# City of Corpus Christi

### Planning Commission

**TECHNICAL REVIEW PLAT REQUIREMENTS  
REGULAR PLANNING COMMISSION MEETING  
July 10th, 2024**

**LONDON TOWNE SUBDIVISION UNIT 8A (FINAL OF 13.144 ACRES)**

## Plat of *London Towne Subdivision* *Unit 8A*

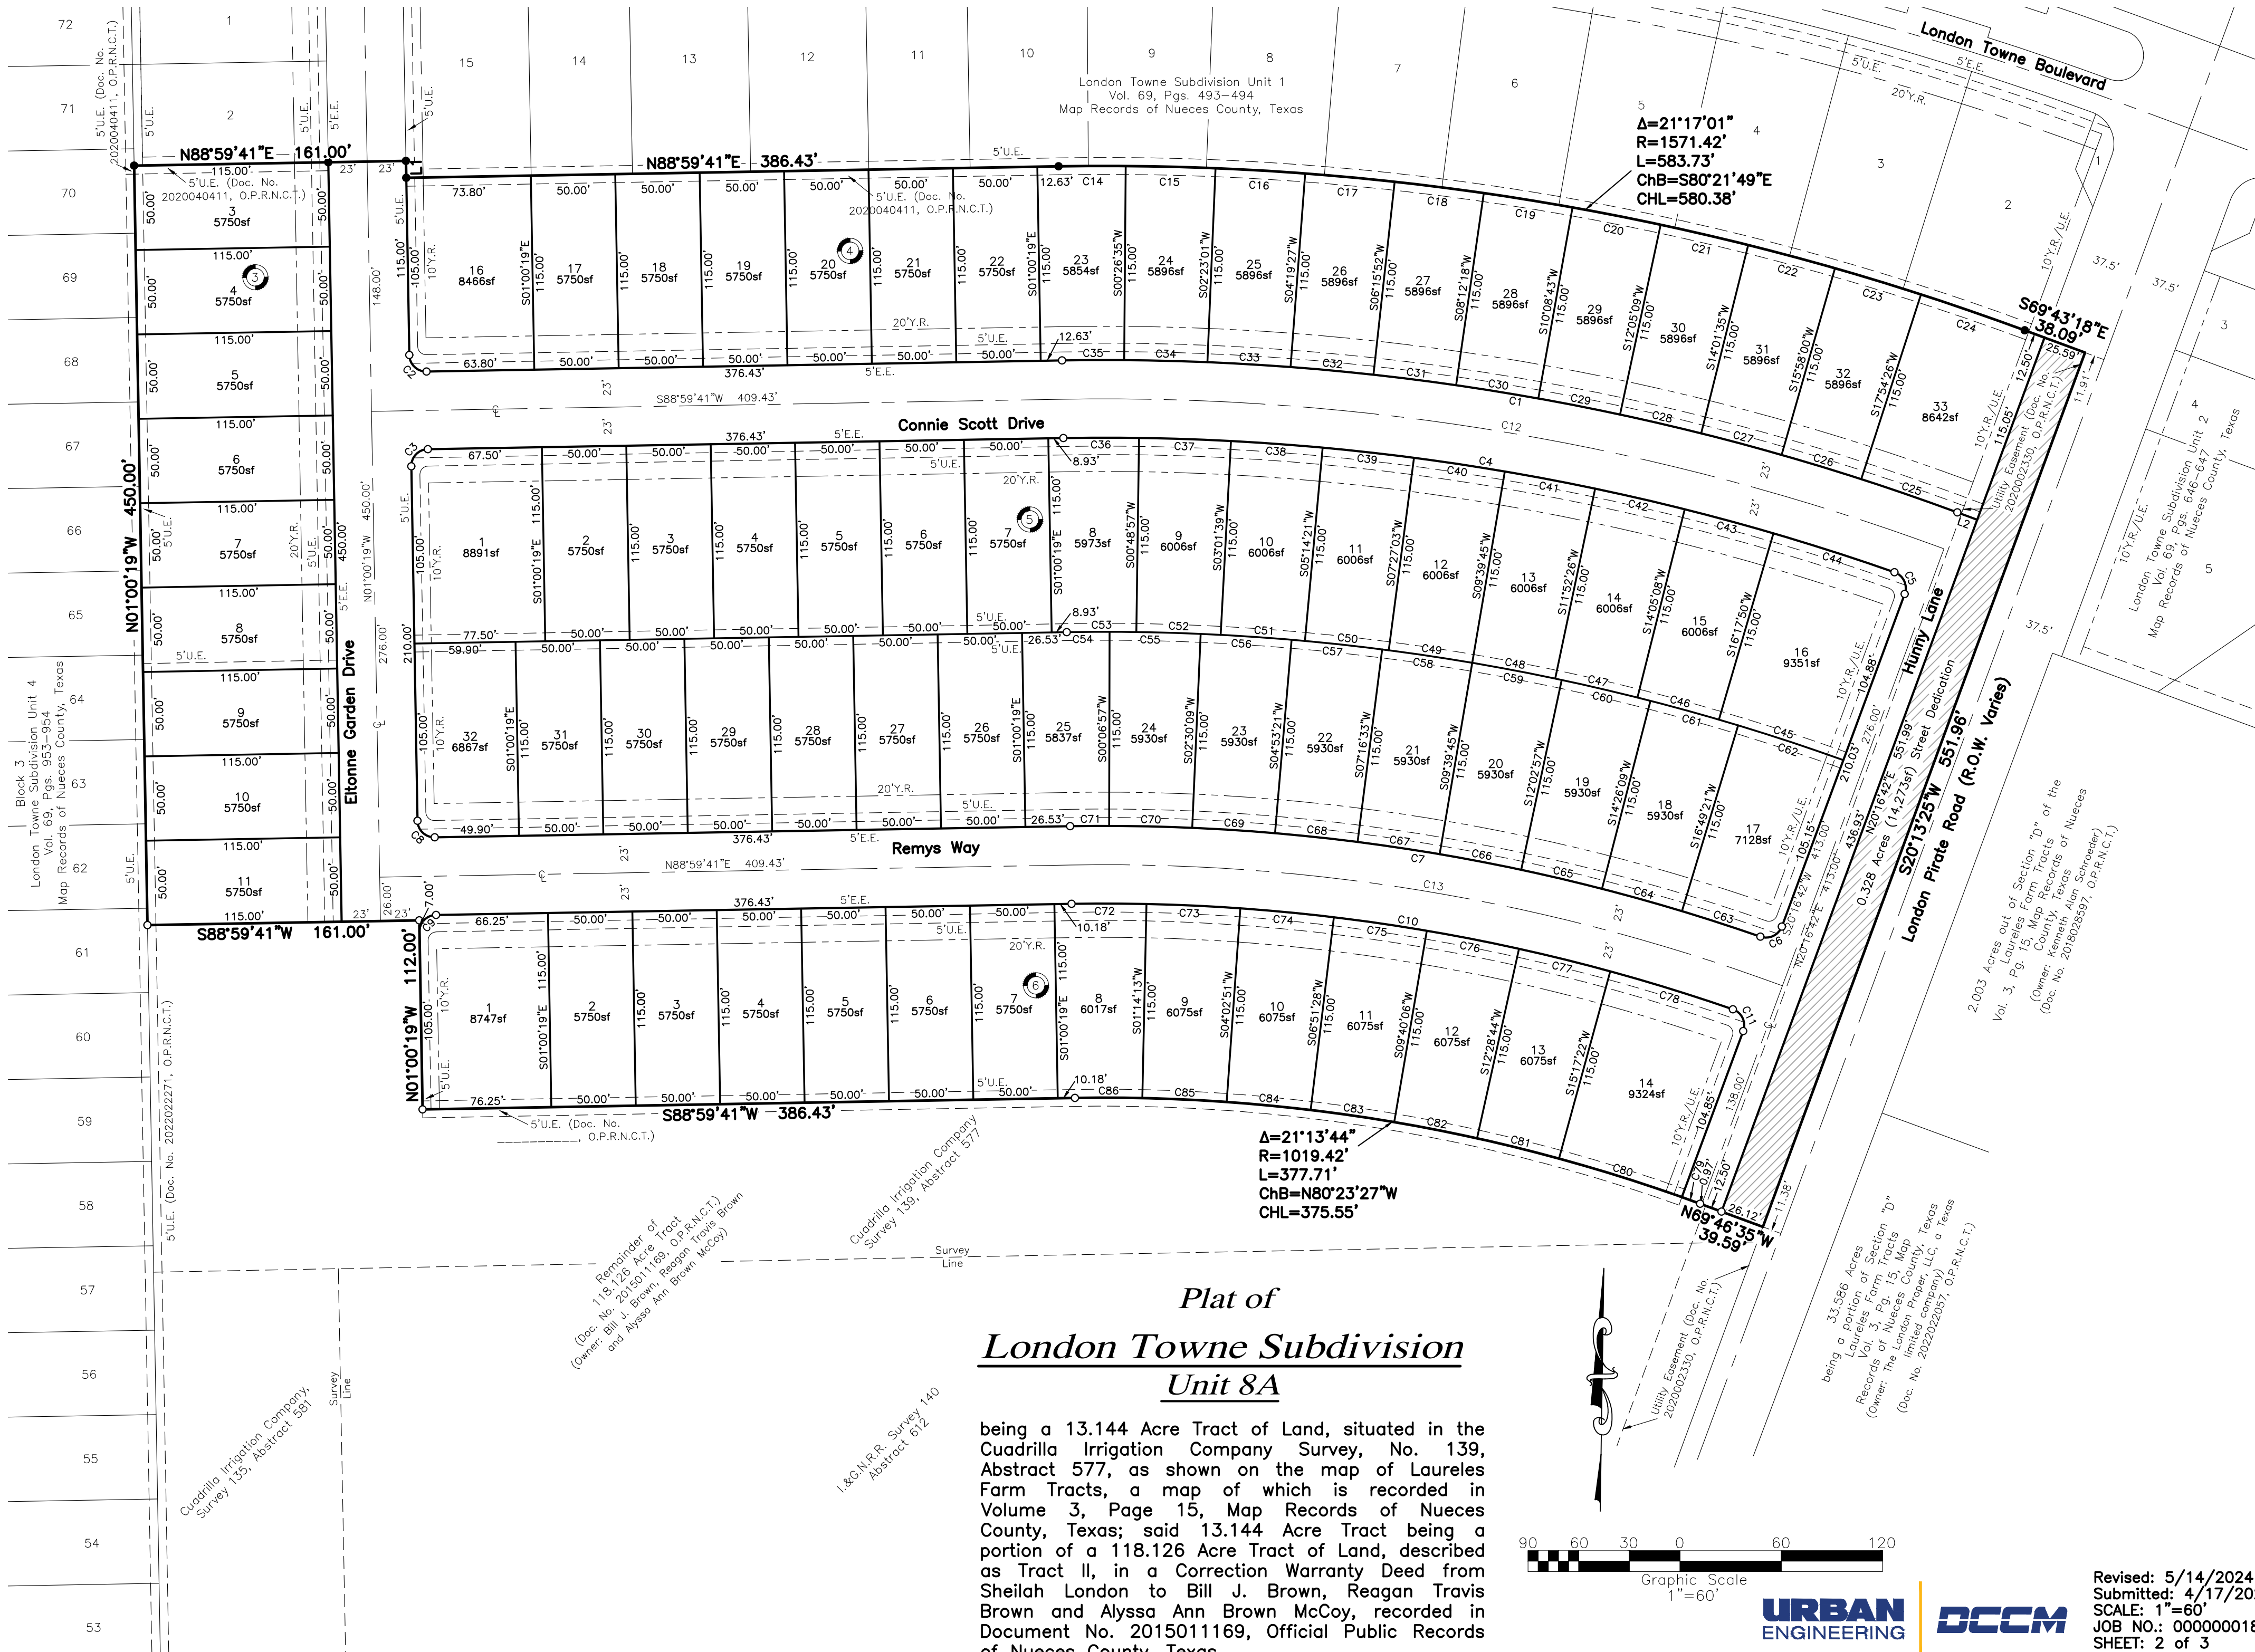
Comment ID	Page Reference	Annotation Type	Author : Department	Status	Review Comments	Applicant Response Comments
8	plat1	Note	Andrea Fernandez : DS	Closed	NCAD Comment: We currently have the ownership as undivided interest account 0286-0020-0100.	
9	plat1	Note	Andrea Fernandez : DS	Closed	AEP Transmission: No comment	
10	plat1	Note	Andrea Fernandez : DS	Closed	AEP Distribution: No comment	
11	plat1	Note	Andrea Fernandez : DS	Closed	CCRTA Comment: This plat is not located along any existing or foreseeably planned CCRTA service route	
21	plat1	Note	Andrea Fernandez : DS	Closed	GIS: This plat DOES NOT CLOSE within acceptable engineering tolerances. UPDATED 5/7: 1PlatThe plat closes within acceptable engineering standards.	
22	plat1	Note	Andrea Fernandez : DS	Closed	Fire comments 1-8: 1PlatWater Distribution Standards: Fire flow for residential areas require 750 GPM with 20 psi residual 2Plat507.5.1 Exception 1: Group R-3 (one- or two-family dwellings): Fire hydrants to be located every 600 feet apart. 3Plat33310.1 Required access. Approved vehicle access for firefighting shall be provided to all construction or demolition sites. Vehicle access shall be provided to within 100 feet of temporary or permanent fire department connections. Vehicle access shall be provided by either temporary or permanent roads, capable of supporting vehicle loading under all weather conditions. Vehicle access shall be maintained until permanent fire apparatus access roads are available. 4Plat102.1 Access and loading. Facilities, buildings, or portions of buildings hereafter constructed shall be accessible to fire department apparatus by way of an approved fire apparatus

23	plat1	Note	Andrea Fernandez : DS	Closed	<p>Fire comments 9-13:</p> <p>9¶Infor.¶"1.¶Where Fire Apparatus Access is constructed to the minimum of 20 feet, no parking is allowed within the fire apparatus lane.</p> <p>2.¶Where a fire hydrant is located on the street, the minimum unobstructed clearance shall be 26 feet. In this instance, no parking is allowed on one side of the street.</p> <p>3.¶The minimum UDC residential street width is 28 ft. curb to curb. Any parking along the street that reduces the width to less than 20 ft. is prohibited and the Fire Code Official and will require painting "NO PARKING-FIRE LANE" along one side of the street."</p> <p>¶Infor.¶"Note: Calculated Turning Radii for Fire Apparatus:  Inside Turn: 20 ft. 3 in.  Curb to curb: 36 ft. 8 in.  Wall to wall: 44 ft. 8 in."</p> <p>10¶Plat¶503.4 Obstruction of fire apparatus access roads. Fire apparatus access roads shall not be obstructed in any manner, including the parking of vehicles. The minimum widths and clearances established in sections D103 shall always be maintained.</p>

Comment ID	Page Reference	Annotation Type	Author : Department	Status	Review Comments	Applicant Response Comments
					<p>11 Plat 503.3 Marking: Where required by the fire code official, approved signs, or other approved notices the include the words NO PARKING-FIRE LANE shall be provided for fire apparatus access roads to identify such roads to prohibit the obstruction thereof. The designation of a fire lane can be marked with conspicuous signs which have the words: "Fire Lane-No Parking" at 50-foot intervals. In lieu of signs, fire lanes may be marked along curbing with the wording, "Fire Lane-No Parking" at 15-foot intervals.</p> <p>12 Plat 503.2.5 Dead ends. Dead-end fire apparatus access roads more than 150 feet in length shall be provided with an approved area for turning around fire apparatus.</p> <p>13 Plat Table D103.4 Requirements for Dead-end fire apparatus access roads. Turnaround provisions shall be provided with a 96-foot diameter cul-de-sac.</p>

24	plat1	Note	Andrea Fernandez : DS	Closed	<p>Parks: No comments</p> <p>Park Development Fee "Fee in Lieu of Land" Dwelling Units: 73 Fee: \$65.50 Total Due: \$33,762.50 UPDATED: Per Park Improvement Agreement for London Towne Subdivision, developer shall be granted credits as to go in lieu of fees.</p>	
25	plat1	Note	Andrea Fernandez : DS	Closed	<p>Planning comment: Remove red preliminary text off all plat pages</p>	
26	plat1	Note	Andrea Fernandez : DS	Closed	<p>Planning comment: Provide plat note stating direct access to London Pirate Road (CR-33) shall not be permitted. UPDATED: Revise to say "Direct access to London Pirate Road shall not be permitted"</p>	
27	plat1	Note	Andrea Fernandez : DS	Closed	<p>Planning comment: Owner signature block should reflect owner(s) in NCAD (see comment ID #8) UPDATED: Deeds confirming owner to be provided before final plat recordation</p>	
28	plat2	Note	Andrea Fernandez : DS	Closed	<p>Planning comment: Provide street cross sections (see comment ID #19) UPDATED: Provide street cross section for London Pirate Road (CR-33) RESOLVED PER MEETING 5/13</p>

## Preliminary Stormwater Quality Management Plan of London Towne Subdivision Unit 8A

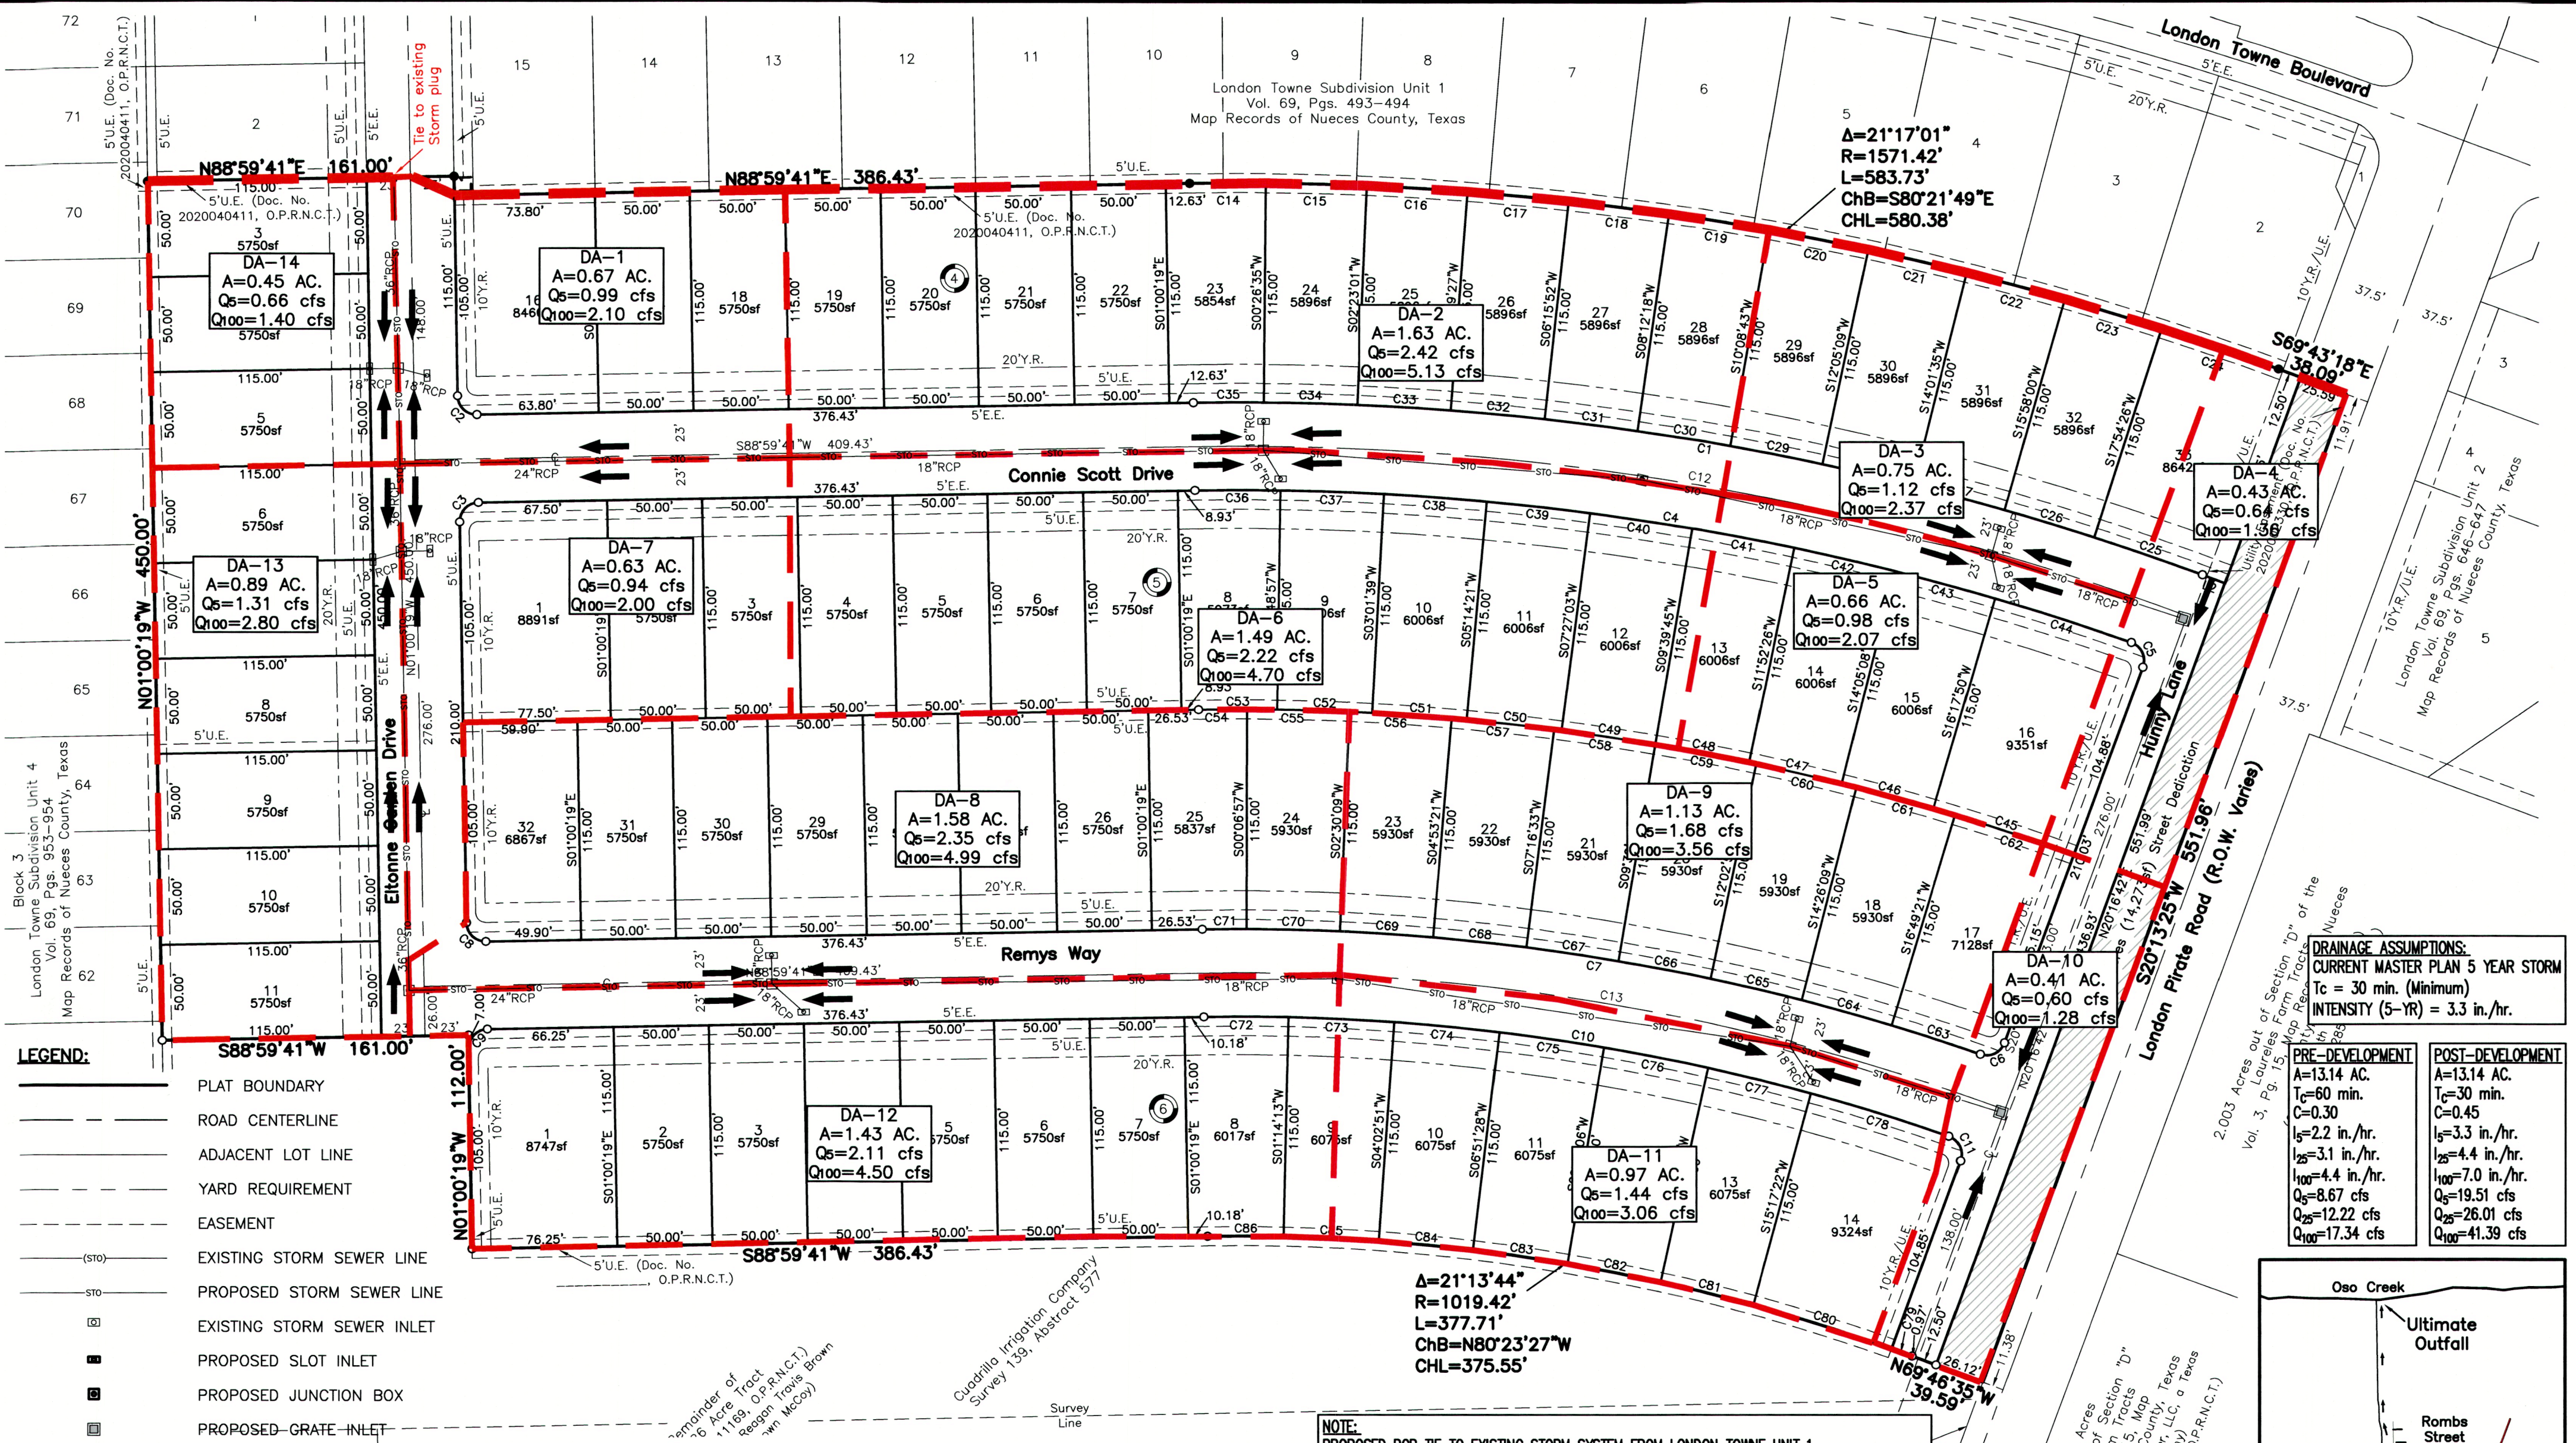
Comment ID	Page Reference	Annotation Type	Author : Department	Status	Review Comments	Applicant Response Comments
					15□Informational:□Working without an approved ROW Construction Permit will be considered non-compliance and can be subject to fines and / or citations.	
12	plat1	Note	Alex Harmon : ENG	Closed	"Improvements Required for Recordation, per UDC 8.1.4. A. Streets: yes Sidewalks: yes, per 8.2.2 B. Water: yes C. Wastewater: yes D. Stormwater: yes E. Public open space: no F. Permanent monument markers: no  Please note, improvements required should be constructed to city standards, found in Article 8 and the IDM. "	
19	plat2	Note	Alex Harmon : ENG	Closed	Provide typical cross-section of proposed streets displaying appropriate MPO including street width and sidewalk trails (UDC 8.2.1)	
31	plat2	Callout	Alex Harmon : ENG	Closed	Pending further review by traffic and streets	
14	1	Callout	Alex Harmon : ENG	Closed	This should be titled "Preliminary Stormwater Quality Management Plan of...."

15	1	Note	Alex Harmon : ENG	Closed	6/25/24 Per Al and Bria drainage to be resolved separately so plat can move forward.  Review IDM 3.05: No Adverse Impacts. For new developments and other improvements that will increase the impervious cover, decrease the time of concentration (Tc), or increase peak flows from drainage areas, mitigation of adverse storm water impacts shall be required. Mitigation methods shall be designed to release the post-development storm water runoff from a site at a controlled rate, which does not exceed the predeveloped peak runoff rate. Habitable structures must be mitigated to the 100-yr-storm event per UDC 8.2.8	
16	1	Note	Alex Harmon : ENG	Closed	6/25/24 response: Per Al, Bria and Bart drainage to be resolved separately  5/29/24 response: Either add this note back to the plat "Place plat note (not just on SWQMP, on plat as well) that any increase in stormwater runoff flow rates shall be mitigated to comply with UDC 8.2.A, 8.2.B, and IDM 3.05" and stormwater can be addressed with just PIs, or show that downstream property won't be affected per Al Raymond's e-mail on 5/20/24.

Comment ID	Page Reference	Annotation Type	Author : Department	Status	Review Comments	Applicant Response Comments
30	1	Note	Alex Harmon : ENG	Closed	Comparing the "max HGL elevation attained 100-yr" and the grading and paving provided in the public improvement plans, multiple lots would be unbuildable unless the homes are placed on piers or "built-up" as during a 100-yr storm they would be underwater. Per UDC 8.2.8 habitable structures must be mitigated to the 100-yr storm. Mitigate further (or provide further analysis/retention showing this max HGL won't be met) or adjust grading to avoid lots being recorded as unbuildable.	
13	Utility Map	Note	Alex Harmon : ENG	Closed	Any work done in the ROW will require a separate permit from the building permit through ROWmanagement@ctctexas.com. Refer to driveway design standards in UDC 7.1.7	
17	Utility Map	Callout	Alex Harmon : ENG	Closed	This should be titled "Preliminary Utility Plan of.."

**Preliminary Utility Plan of  
London Towne Subdivision  
Unit 8A**

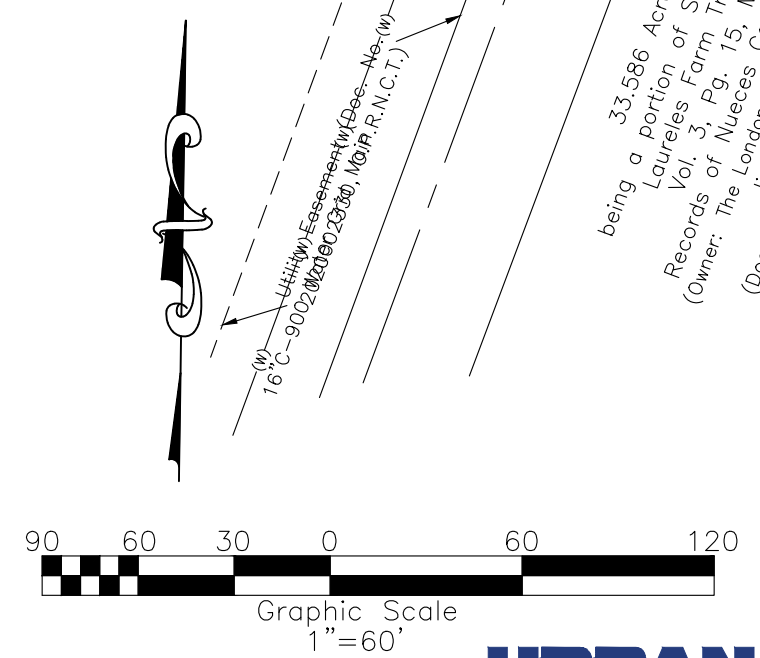
18	Utility Map	Note	Alex Harmon : ENG	Closed	Include estimated water and wastewater usage on utility plan to ensure the proposed development is in compliance with the Comprehensive Plan, implementation plan and applicable Utility Master Plan and the availability and capacity of public improvements needed to support the development. (Flow units gpd) (UDC 3.8.5.D)	
1	Utility Map	Note	Mikail Williams : WTR	Closed	Water construction is required for platting (UDC 1.2.1.D & 8.2.6; Water Distribution Standards).	
2	Utility Map	Note	John Gonzales : WW	Closed	Wastewater construction is required for platting (UDC 1.2.1.D & 8.2.7; Wastewater Collection System Standards).
